Subject: EOS Defense Systems USA, Inc.,
IBFS File No.: SAT-MOD-20200526-00057; Call Sign: S2982

FCC Question 1

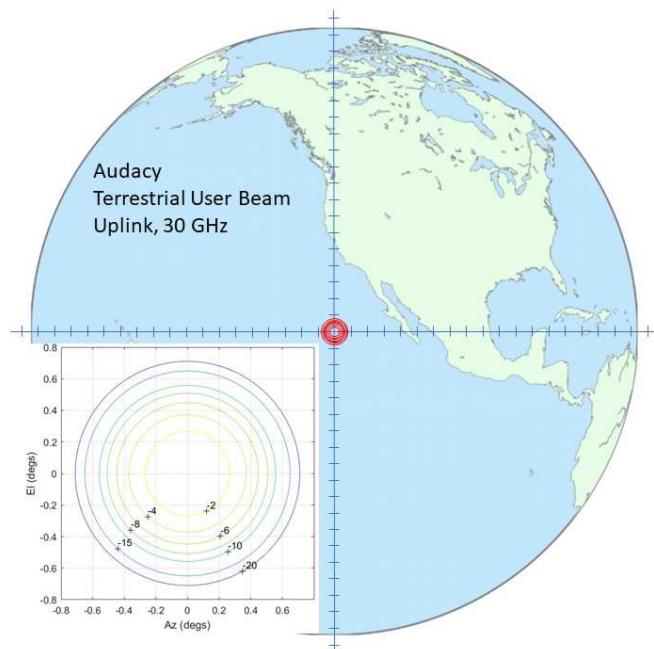
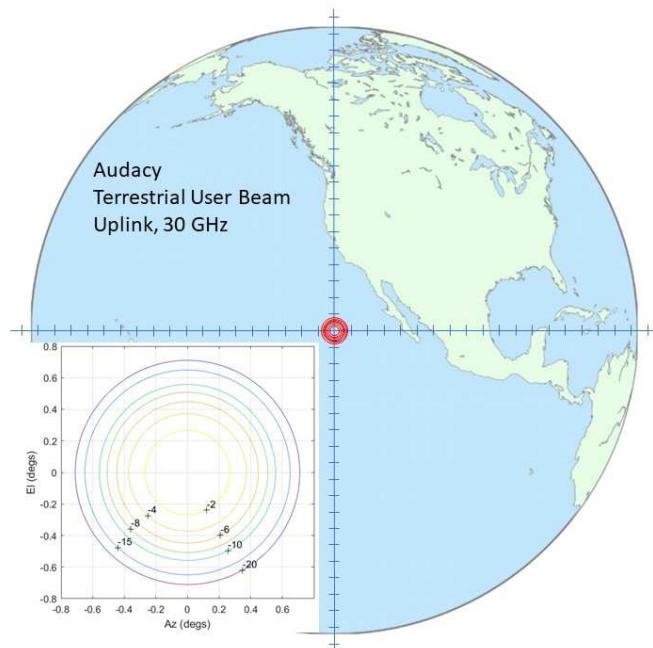
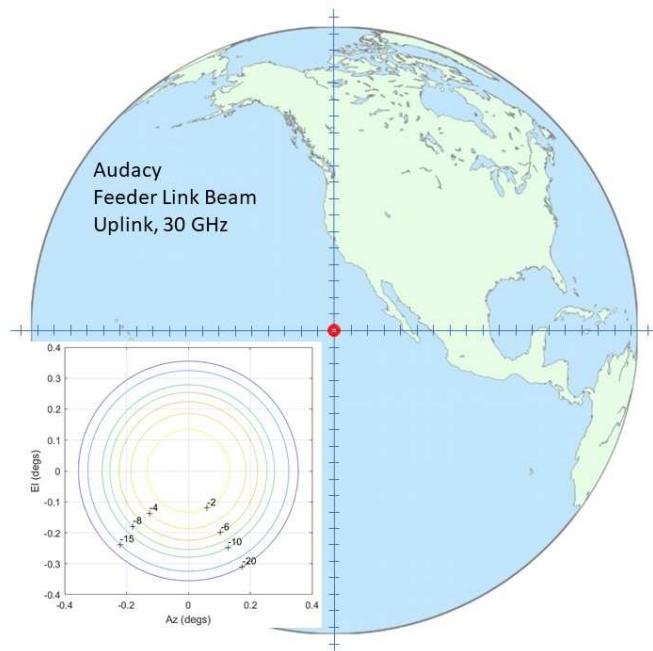
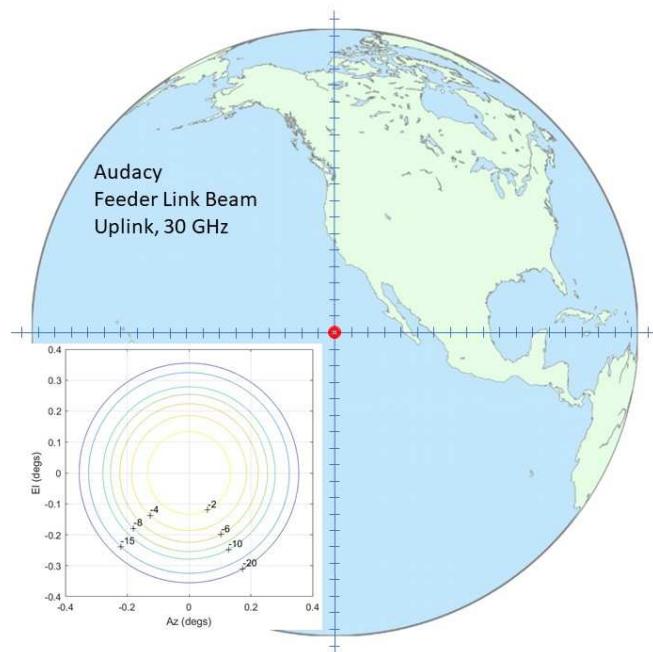
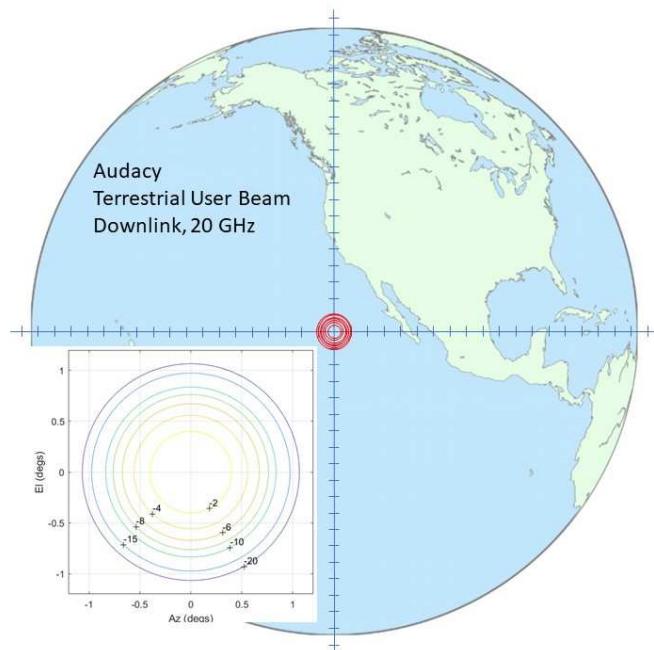
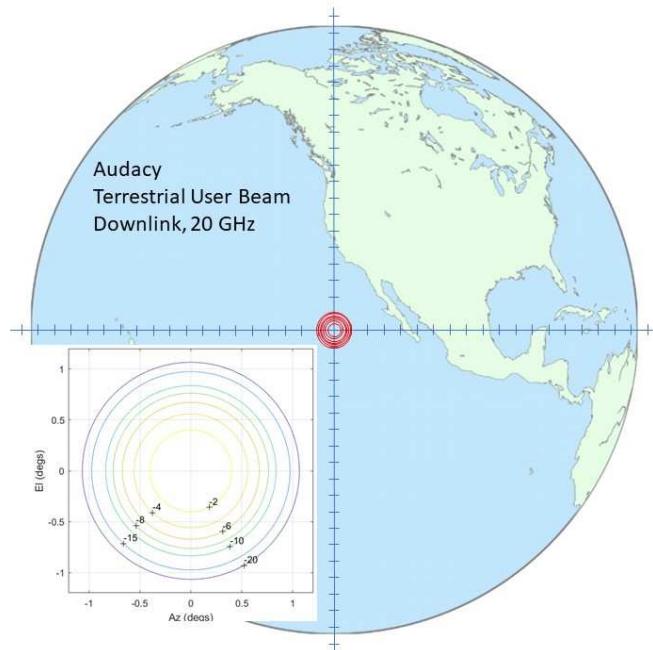
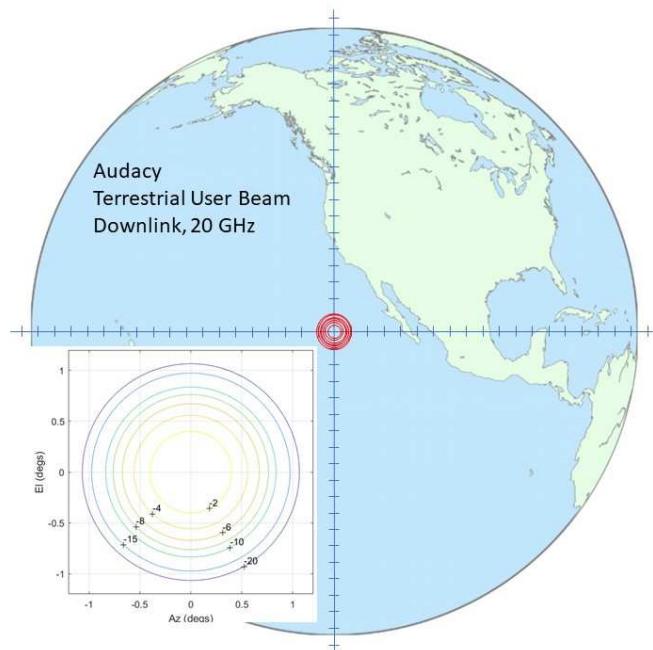
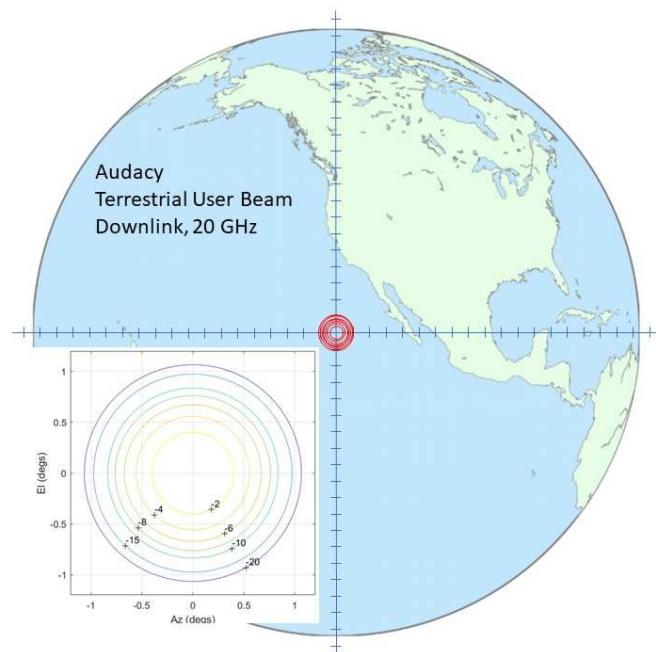
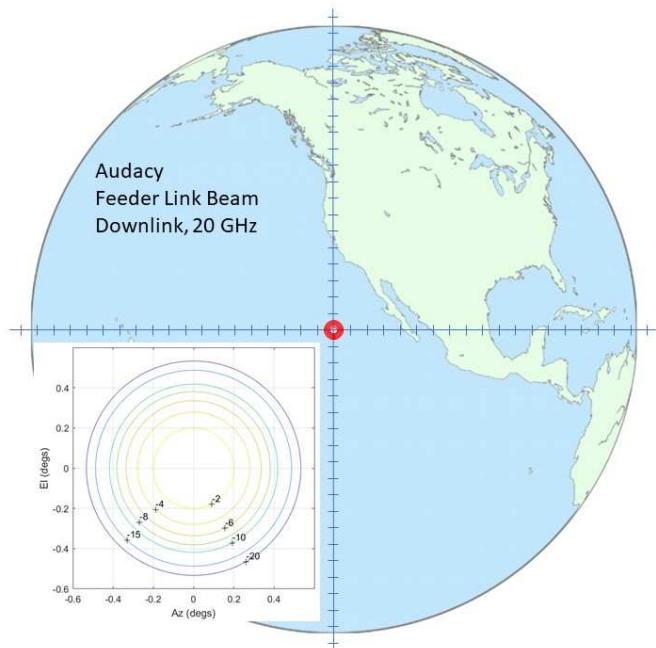
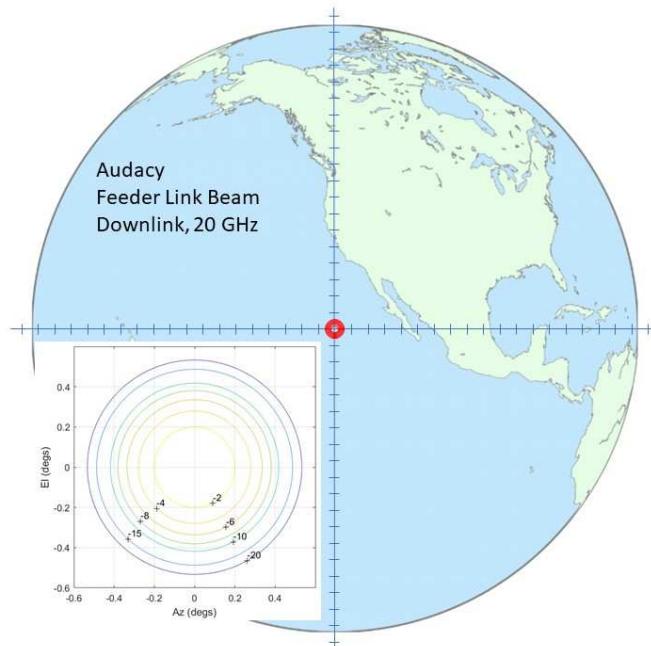
Section 25.114(c)(4)(vi)(B) of the Commission's rules requires that applicants for space stations in non-geostationary orbits specify for each unique orbital plane the predicted antenna gain contour(s) for each transmit and receive antenna beam for one space station if all space stations are identical in the constellation. In the Schedule S provided by EOS, six transmitting beams and

four receiving beams are included, for a total of ten beams. However, there are just four antenna gain contour diagrams attached to the Schedule S, apparently representing only the new feeder link beams. Please provide the required beam diagrams for the remaining six service beams, i.e., SUR1, SUL1, SDR1, SDL1, SDR2 and SDL2. Also, although not strictly required, we would greatly appreciate if you would provide these diagrams in the GIMS readable format as specified in Section 25.114(c)(vi)(A).

Below please find antenna gain contour diagrams for all relevant beams. Diagrams in the GIMS readable format as specified in Section 25.114(c)(vi)(A) have been burned to compact discs and filed concurrently under a separate cover letter.
